October 2023 Planning Commission Meeting Agenda Item No. 3

FIRE Restoration Warehouse
Design Review- 6075 Duniway Avenue

Proposed Project:
Construction of a new 7,500 square foot warehouse storage building.

Proposed Site Plan

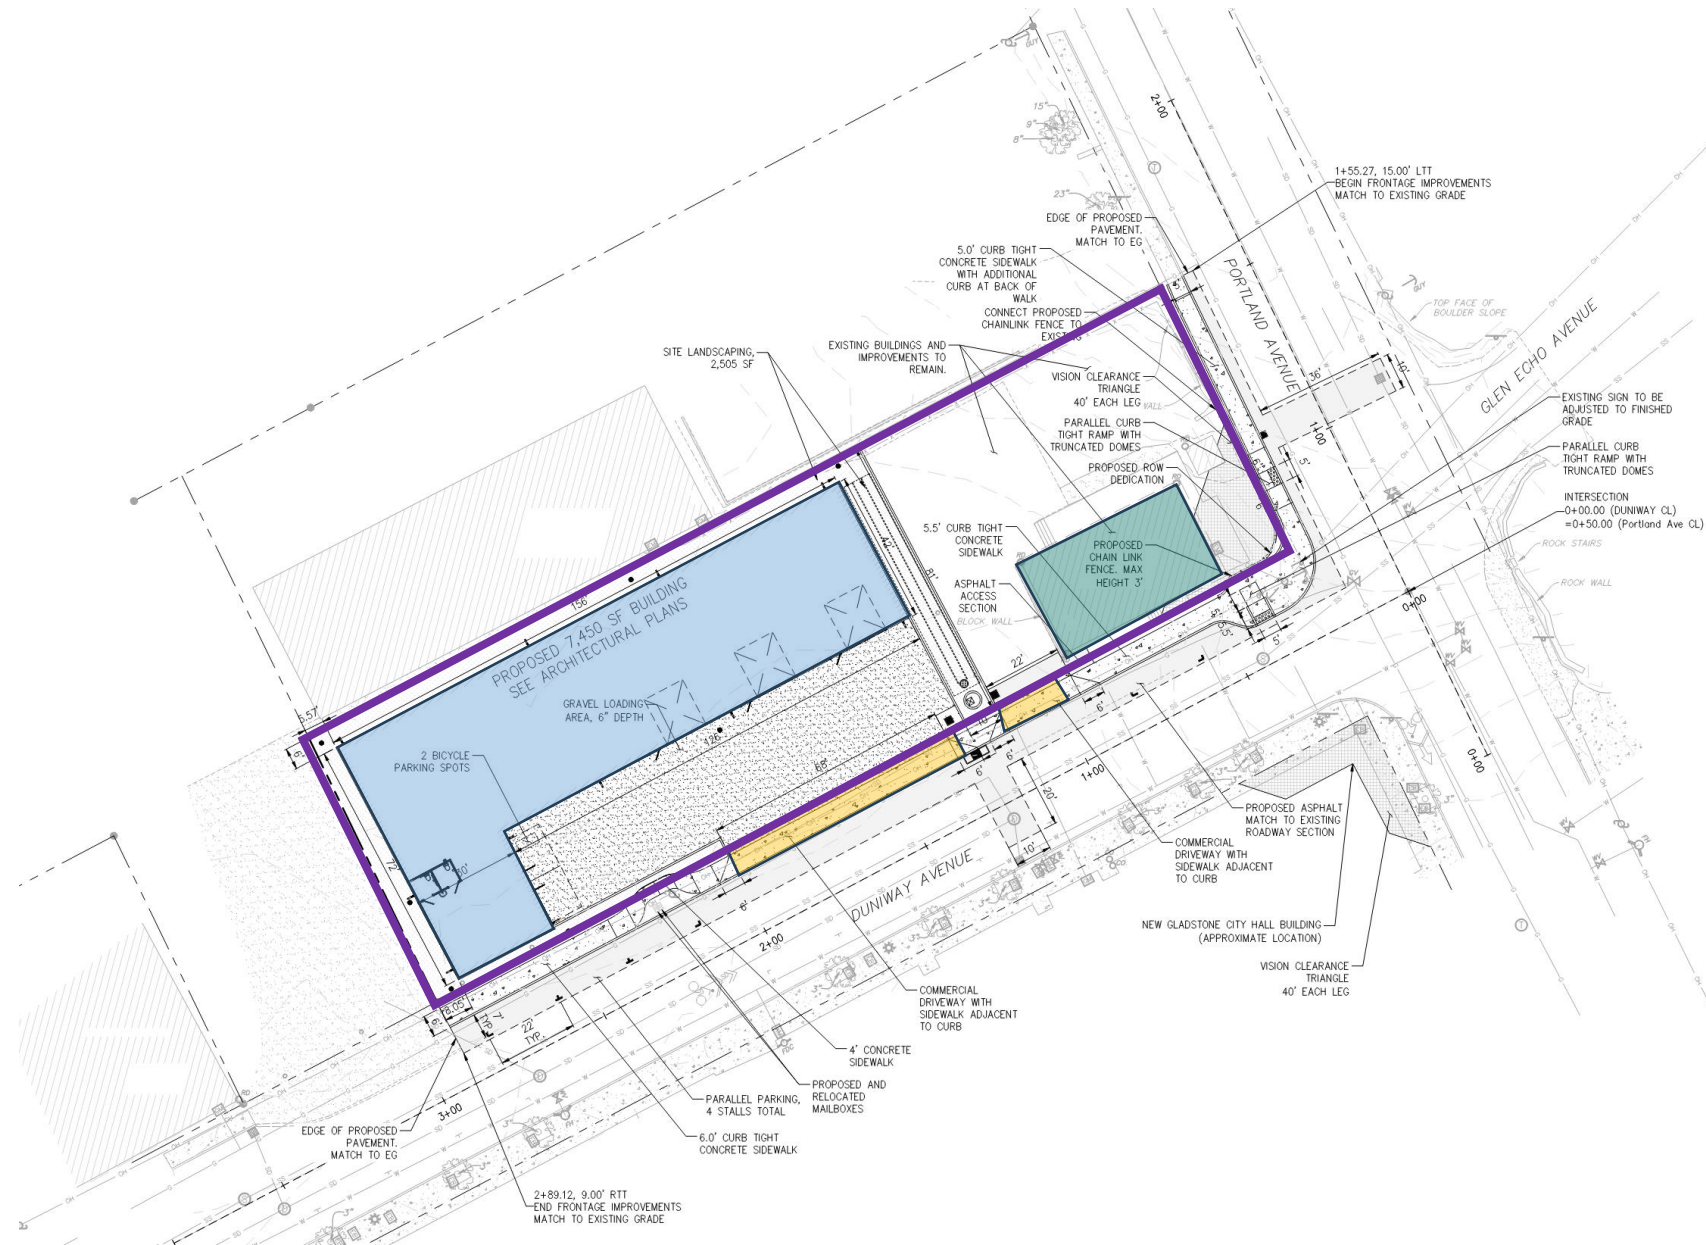
- Site photometrics
- Compliance with the trash disposal and recycling collection provisions
- Minimum 3,333 sf of landscaping, including a 10 ft wide landscaped strip along Duniway Ave.

- Landscaping irrigation and maintenance, overall plant species and street tree details
- Loading area constructed of asphalt or concrete
- Compliant design of the two short-term bicycle parking spaces

- Minimum 6' wide ADA-compliant pedestrian pathway connecting the public sidewalk along Duniway Avenue with the main entry on the west end of the building.

Proposed Building Elevations

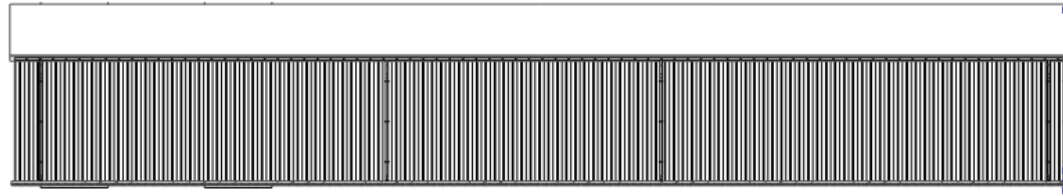
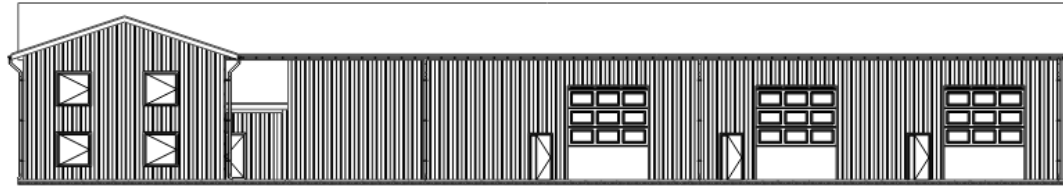
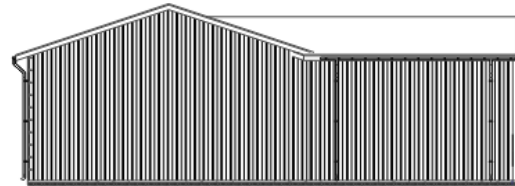
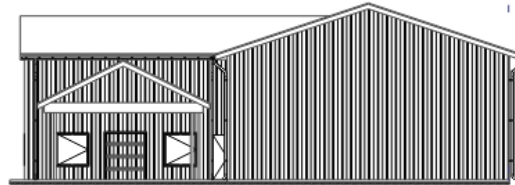
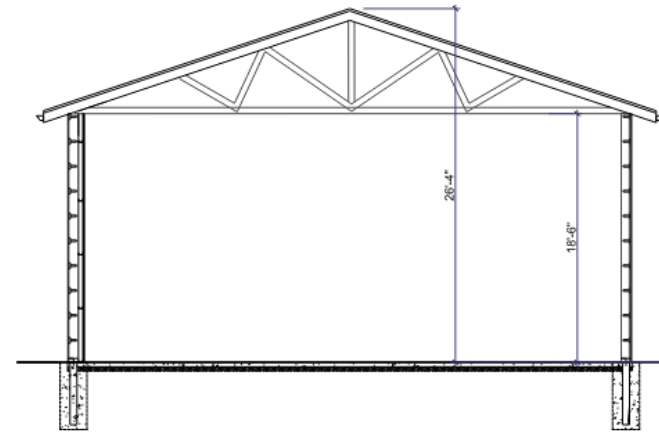
- Skylights or clerestory windows to provide natural lighting and/or solar heating of interior spaces
- Screening for all mechanical equipment, roof-mounted or other above-ground equipment or facilities

- All exterior materials and finishes are high-image such as masonry, architecturally treated tilt-up concrete, glass, wood or stucco and no metal siding is utilized unless specifically approved by the Planning Commission
